ADDENDUM #1 - Additional Items - 4/24/26

New Reading Room & Deck for:

The Pullman Residence
12 Knollwood Drive
West Orange, NJ 07052

General and Specific Notes,
Site Plan, Zoning Info.,
Photos, Exist. Plan & Elev.

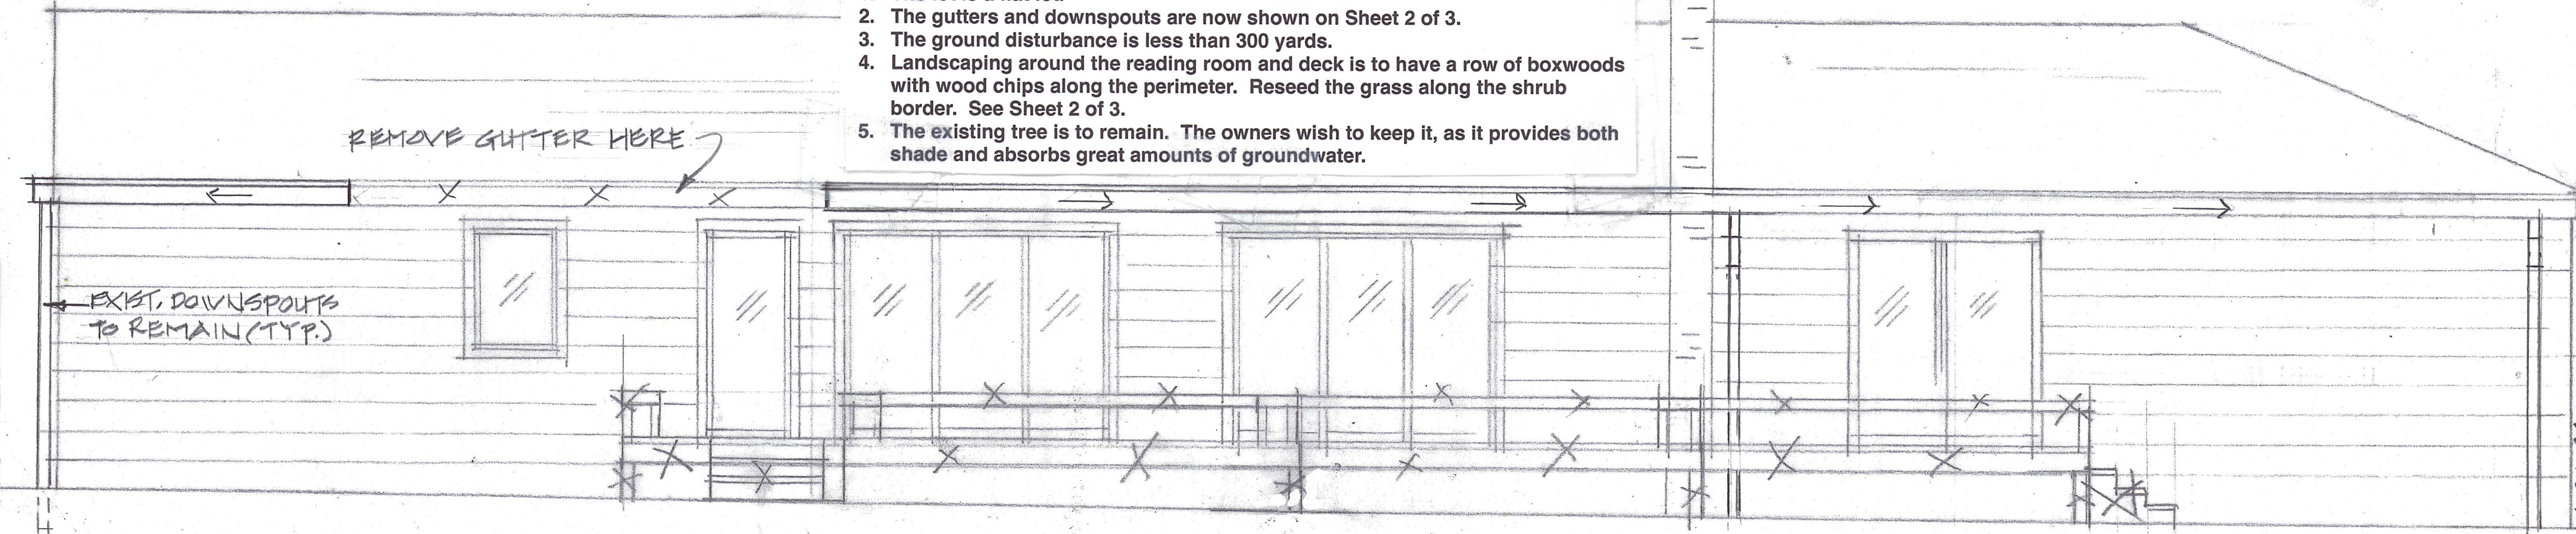
- The lot is a flat lot.
- The gutters and downspouts are now shown on Sheet 2 of 3.
- The ground disturbance is less than 300 yards.
- Landscaping around the reading room and deck is to have a row of boxwoods with wood chips along the perimeter. Reseed the grass along the shrub border. See Sheet 2 of 3.
- The existing tree is to remain. The owners wish to keep it, as it provides both shade and absorbs great amounts of groundwater.
